Application No.: 10/015,569 Docket No.: 4504-044

Amendments to the Drawings:

APPARATUS HAVING A LIGHT SOURCE FOR A TRANSPARENT SHEET OF A SCANNER

Fig. 1A PRIOR ART

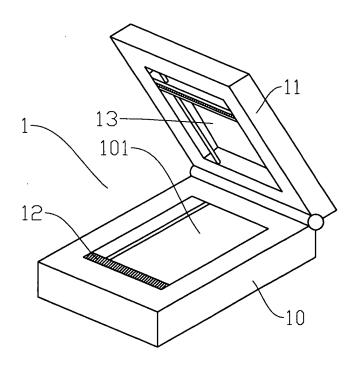
The Examiner states in the Office Action that Figures 1A, 1B, 2A and 2B should be designated by a legend such as --Prior Art-- because only that which is old is illustrated. Attached to this Amendment are Annotated and Replacement Drawings of Figures 1A, 1B, 2A and 2B showing the legend --Prior Art--. Therefore, this objection should be withdrawn.
